AGENDA**Molalla Planning Commission**

6:30 PM, August 7, 2019

**Minutes of the Molalla Planning Commission
Molalla Adult Center
315 Kennel Ave., Molalla, OR 97038
December 5, 2018**

PRELIMINARY GRADING & DRAINAGE PLAN 6-12-19

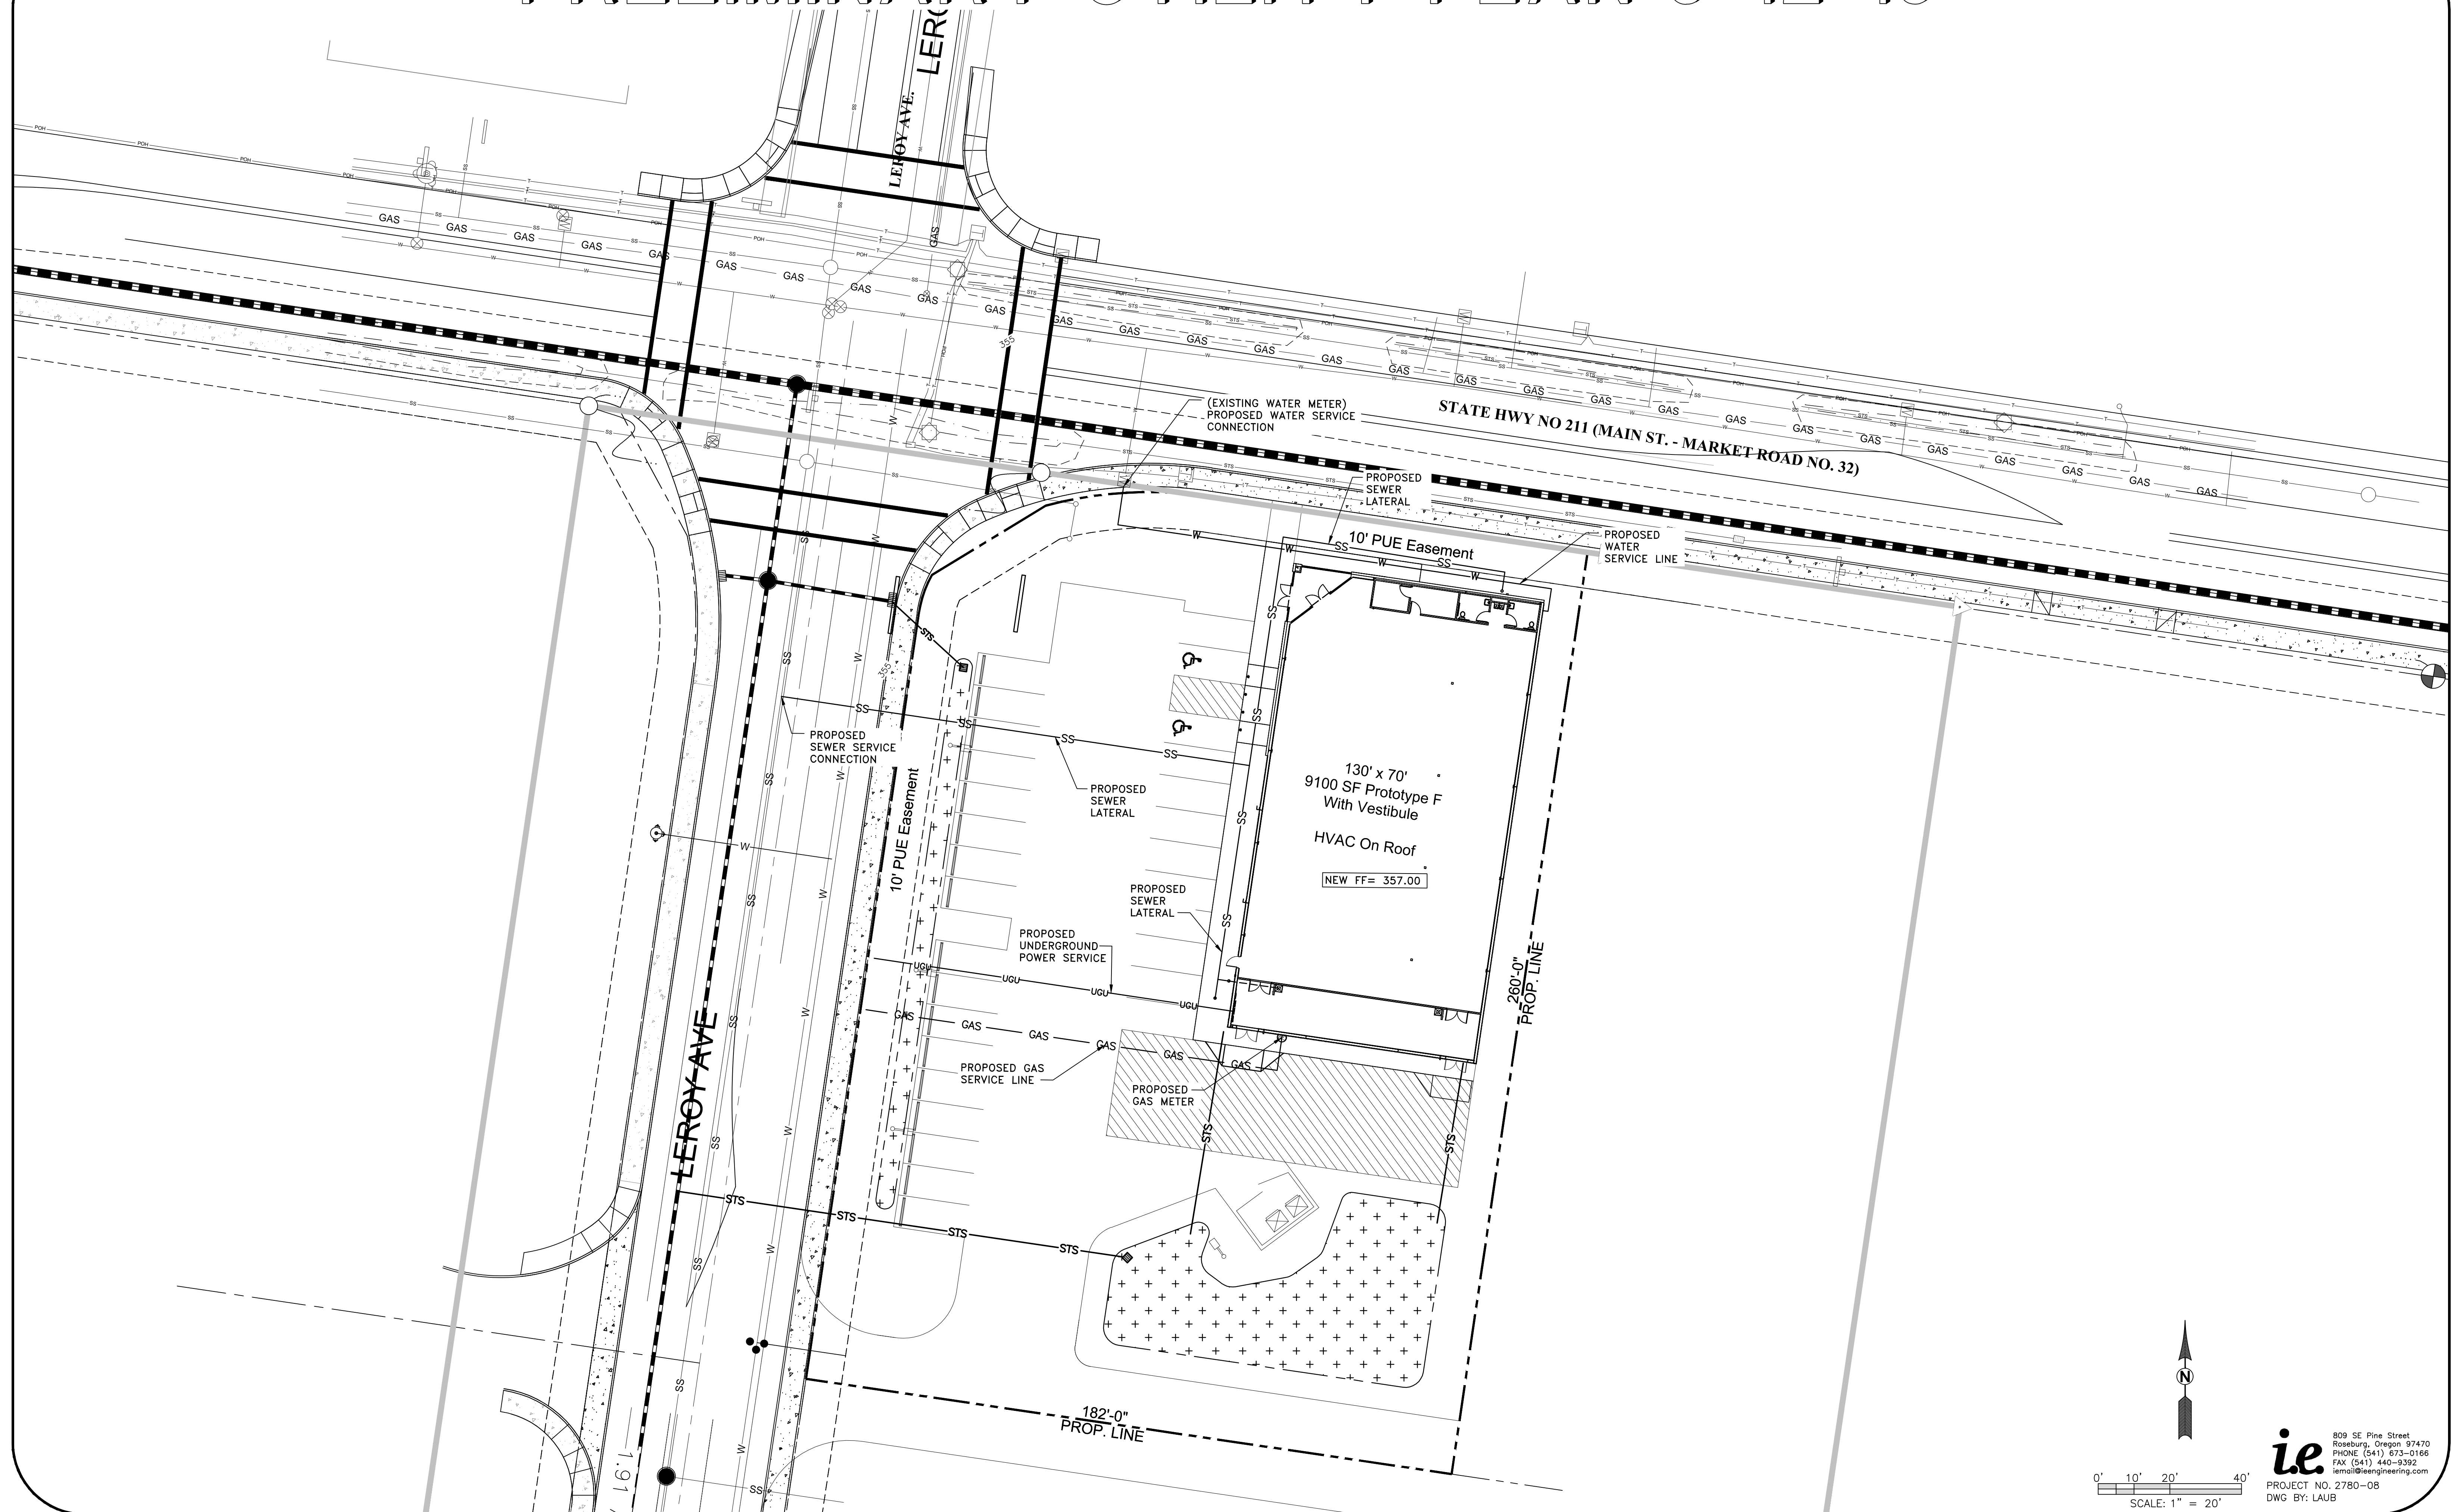
- d. Revise Sheet La.01, the Preliminary Grading and Drainage Plan, and the Preliminary Utility Plan to show pedestrian walkways and crossings interior to the site to meet continuous walkway requirements within the site and to create connectivity between the site and future developments. A continuous pedestrian walkway should be provided on the south and eastern edges of the site.
17-3.3.040 (B) (1-5)

- h. Revise Sheet La.01, the Preliminary Grading and Drainage Plan, and the Preliminary Utility Plan to show a landscaping island on the southern end of this row, between the parking area and cross-hatched truck loading area. Section 17-3.4.030(E)

- i. Revise Sheet La.01, the Preliminary Grading and Drainage Plan, and the Preliminary Utility Plan to show an area for six (6) bicycle parking spaces, as required by Section 17-3.5.040 (A). Bicycle parking design shall confirm with Section 17-3.5.040(B)&(D).

La.01

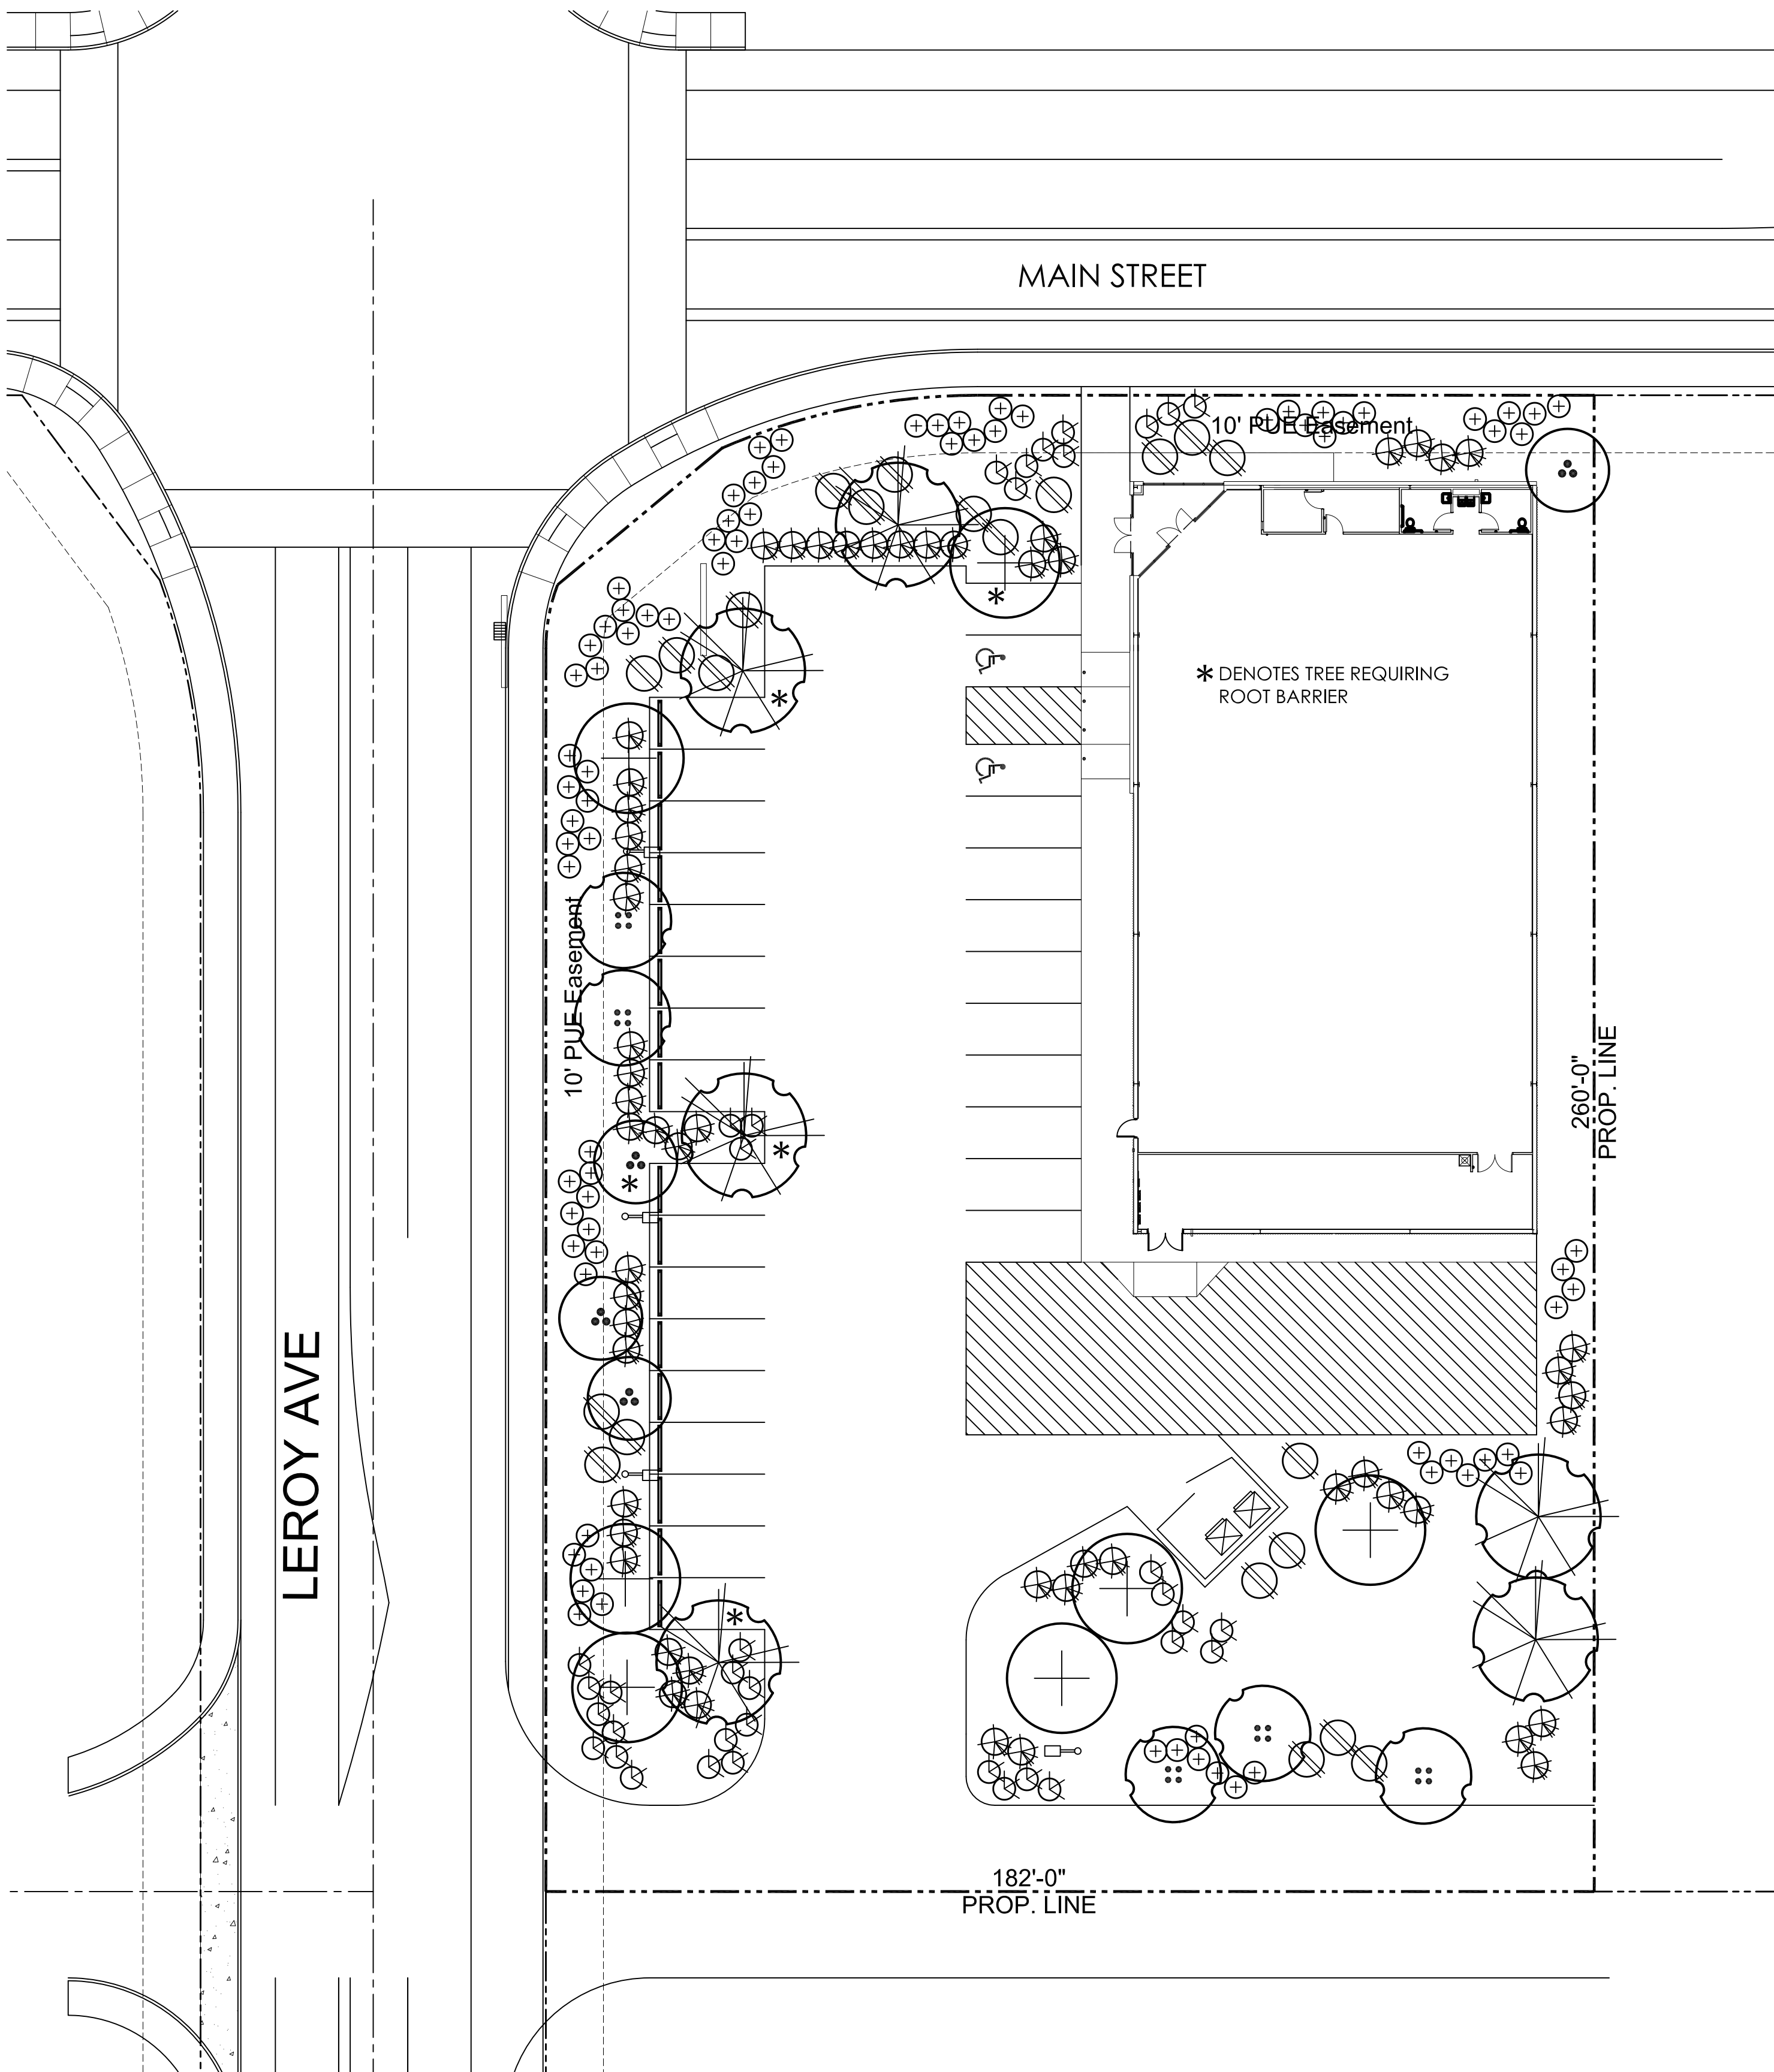
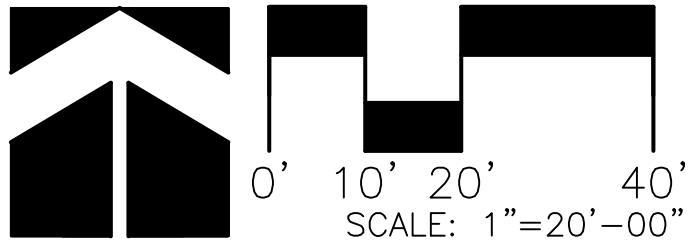
- a. Revise Sheet A02 to wrap the brick façade from the north and south elevations to the eastern elevation, extending across the entirety of the eastern elevation.
17-3.2.040 (E)(2)
- b. Revise Sheet A02 to show the dimensions of the parapet screening or location of the HVAC system on the east, west, and southern elevation plans.
17-3.2.040 (G)(2)
- c. Revise Sheet La.01 to identify all pedestrian amenities on the submitted landscaping site plan, to justify a 10-foot "build to" from the OR-211 property line and the 94-foot "build to" setback from the Leroy Avenue property line. Sheet La.01 shows landscaping in the "pedestrian amenity area, appearing to discourage

its use a plaza space. Please provide a “detail” of this building entrance/” build to” area to demonstrate compliance with Section 17-2.2.040 (E) “Build-To Line.” Consider using tree wells, bicycle parking areas and other amenities to make this an inviting space for pedestrians.

- f. Revise plans to screen all rooftop mechanical, wall-mounted and ground-mounted mechanical equipment and show compliance with 17-3.2.040(G)
- g. Revise Sheet La.01, the Preliminary Grading and Drainage Plan, and the Preliminary Utility Plan to ensure wheel stops, curbs, bollards, or other physical barriers are designed along the edges of all vehicle-maneuvering areas to protect landscaping from being damaged by vehicles. Section 17-3.4.030(E)(4)
